CCK-2590.50-1-25

Asset Preservation Pool - Patterson Office Tower Partial Renovation (5th Floor)

ADDENDUM #3

**UK PATTERSON OFFICE TOWER
FIFTH FLOOR RENOVATION**

C DOOR FRAME TYPES
1/4" = 1'-0"

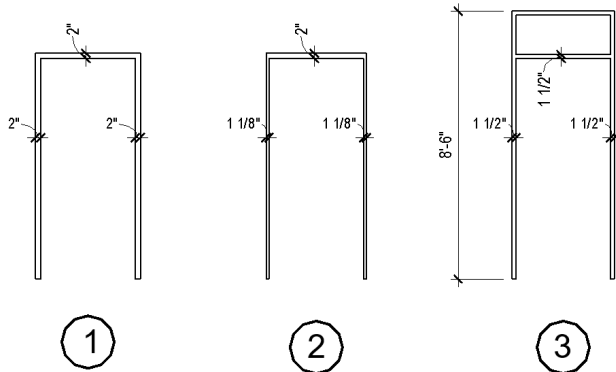
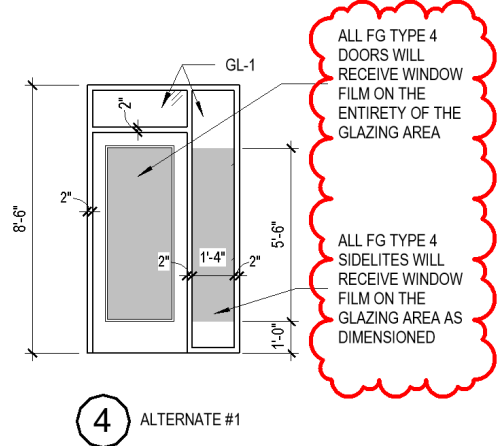
Refer to the attached drawings – the following drawings have been revised and attached to this document:
C/A-601 – All FG type 4 doors will receive window film on the entirety of the glazing area. Refer to drawing G/A-601

ROOM FINISH PLAN & SCHEDULE

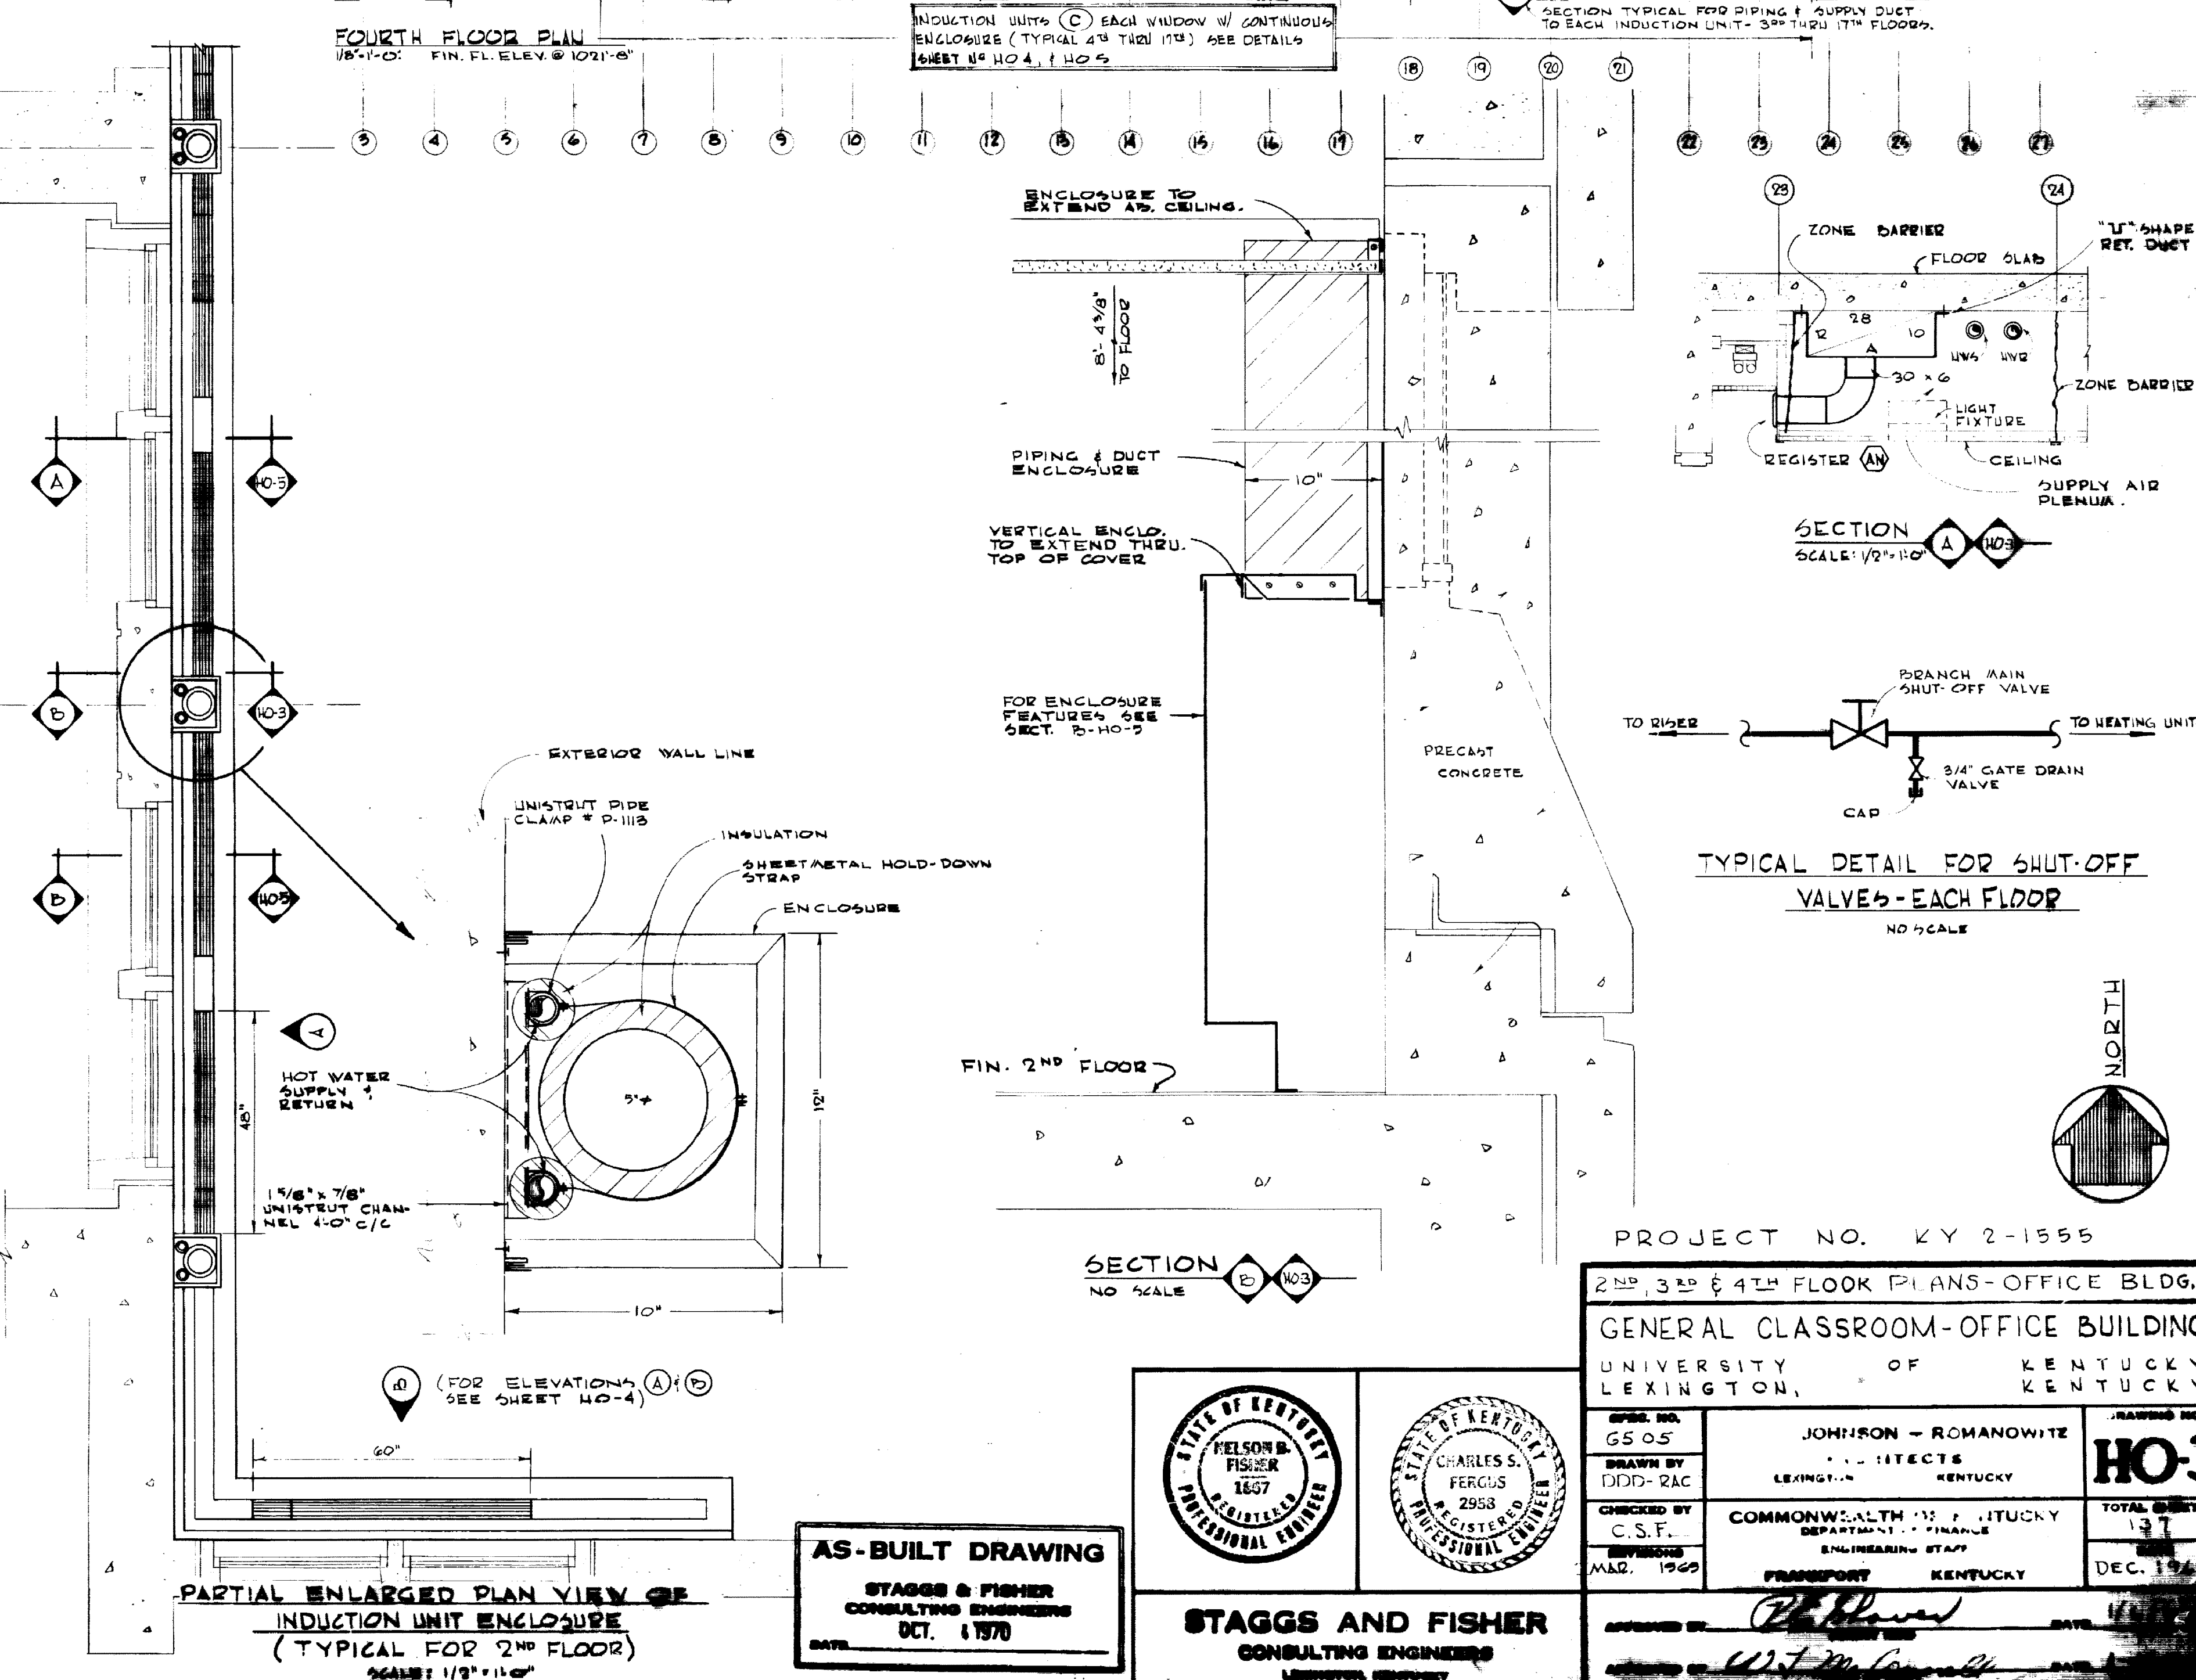
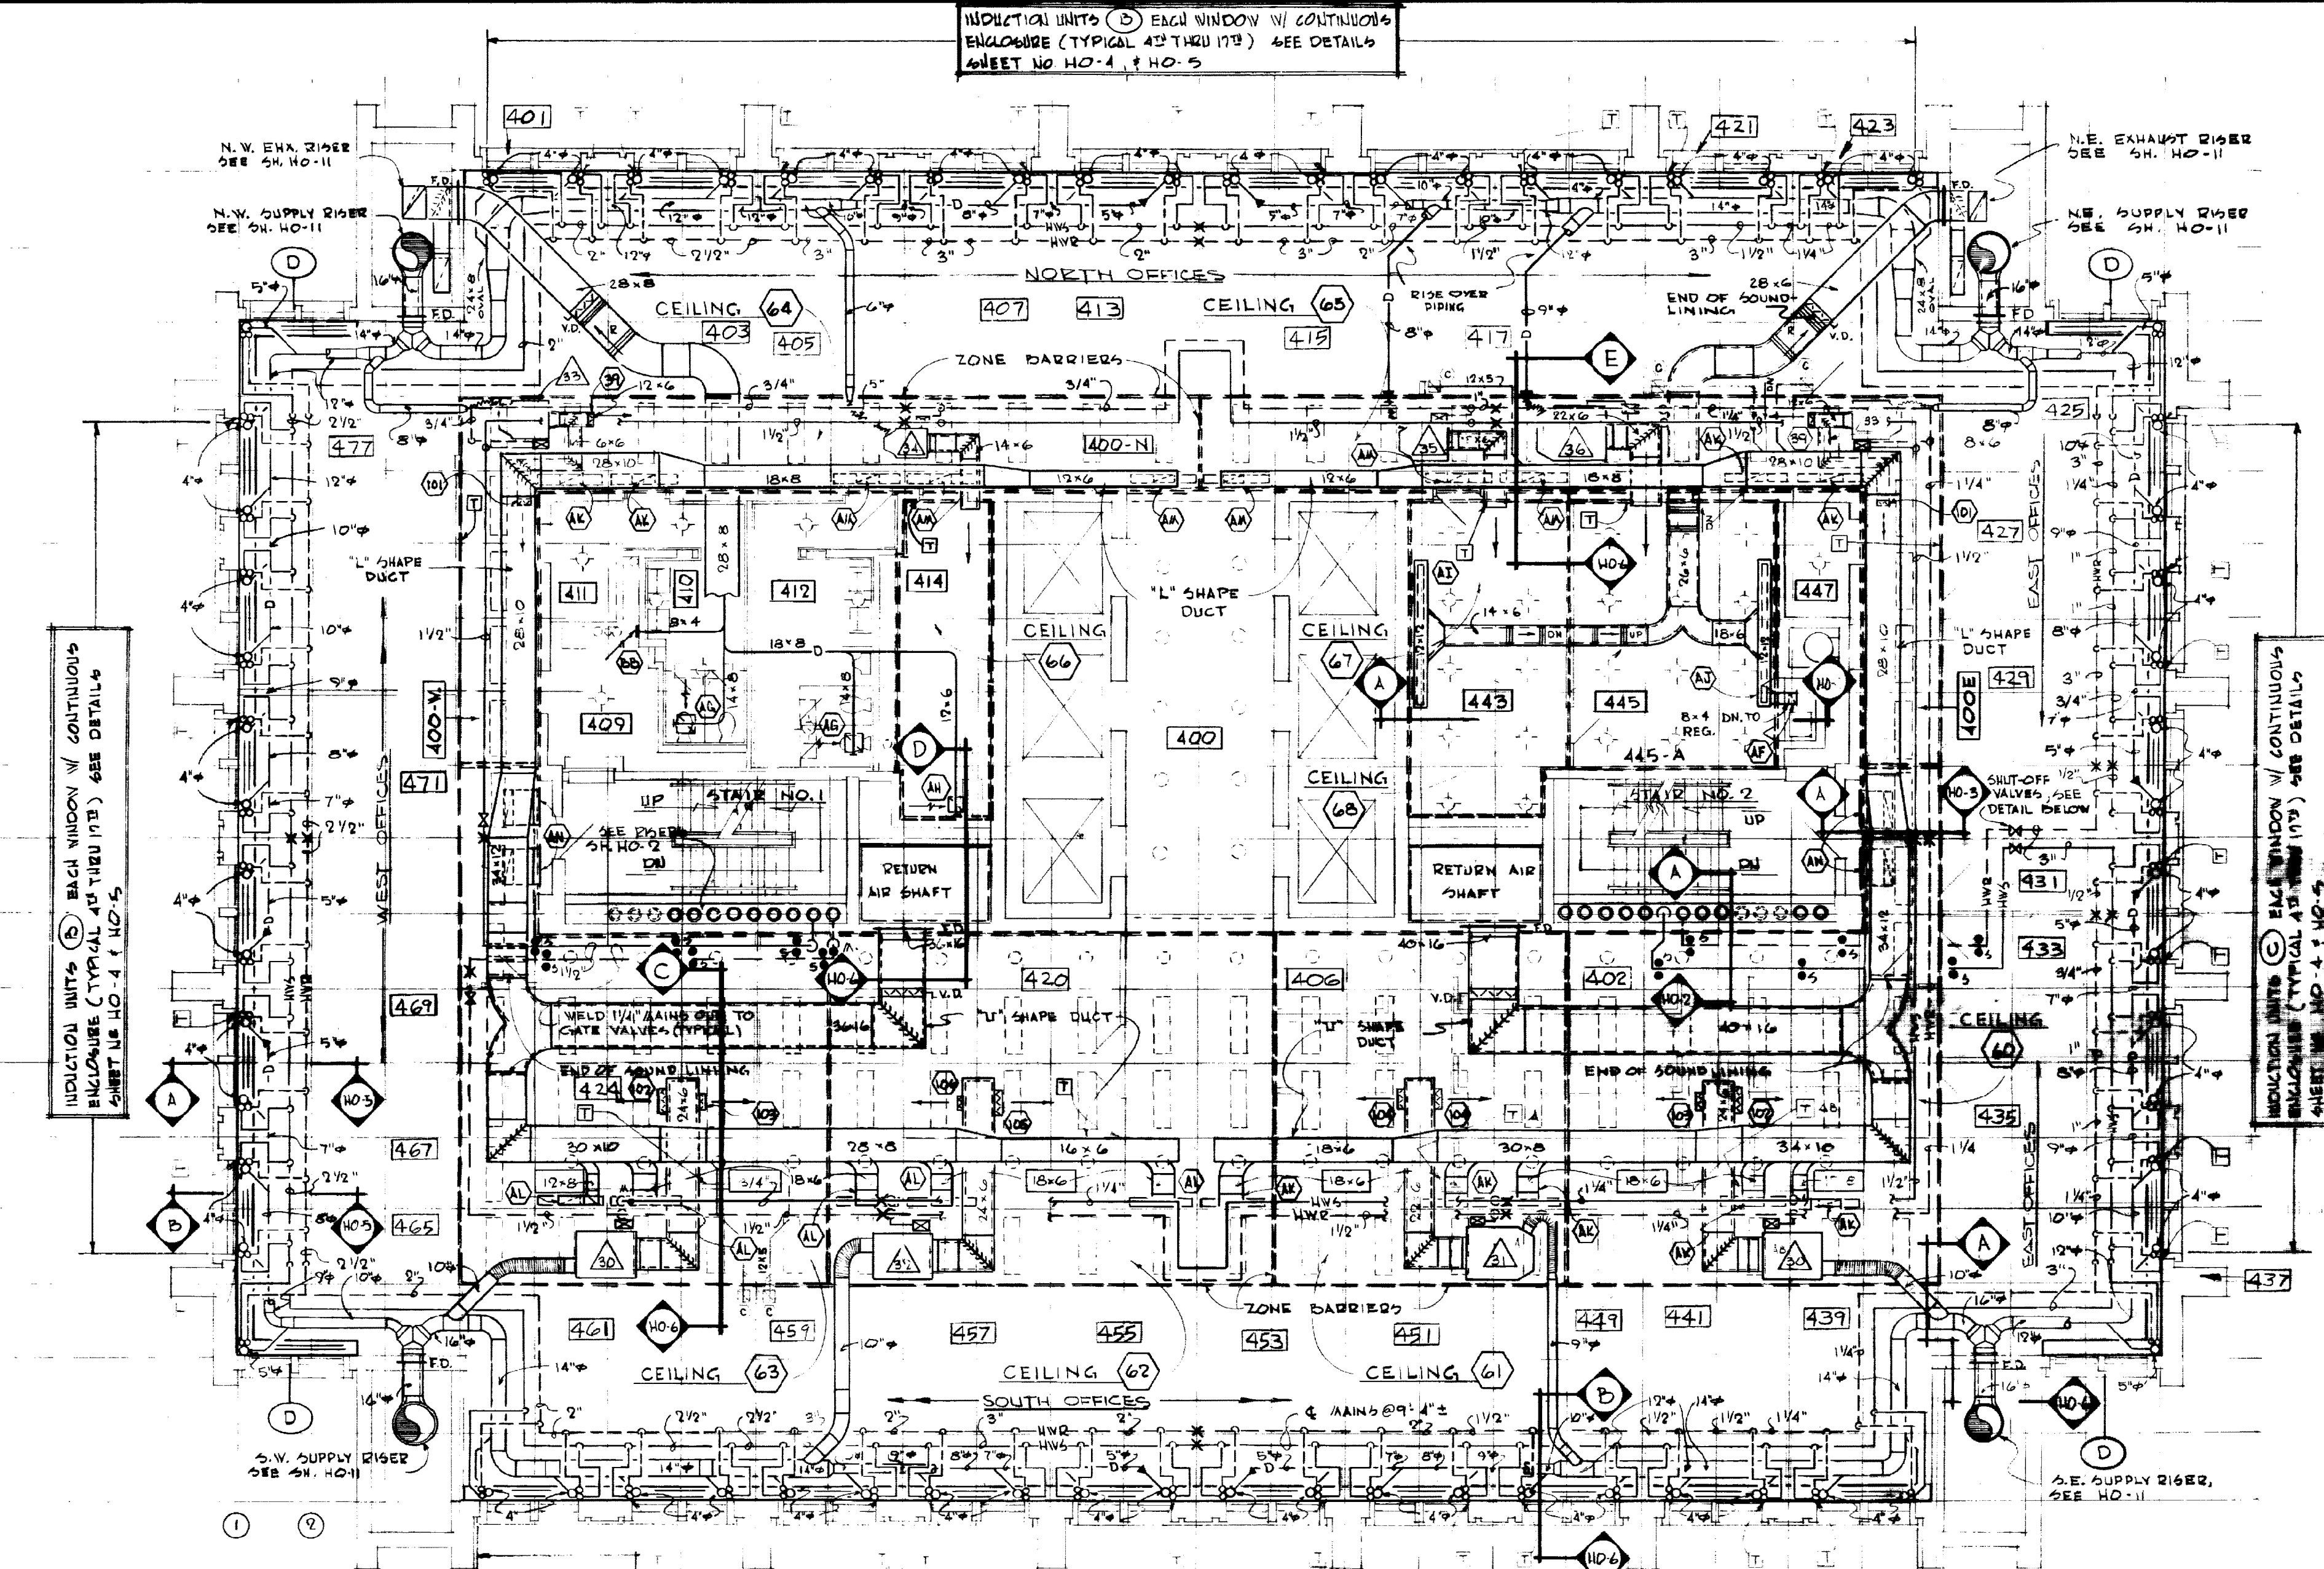
Refer to the attached drawings – the following drawings have been revised and attached to this document:
A-621
